Service information

Reference no.: SDA_78805

Mains switch does not operate

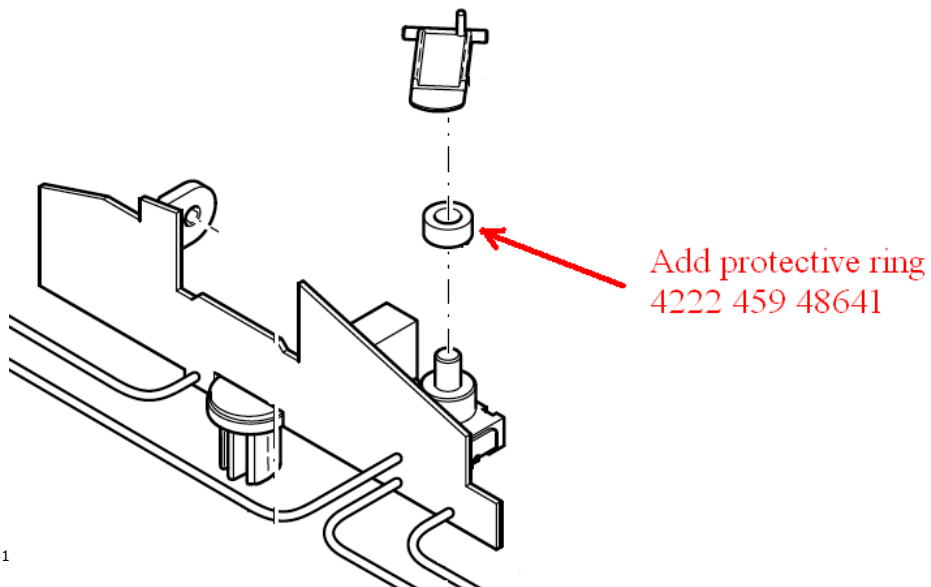
From market returns it became clear that the mains switch gets damaged using too much force on the on/off button!

Appliances are from now on equipped with a protective ring (see attached image). If this ring is missing it must still be placed as modification.
Sparepart code 4222 459

48641
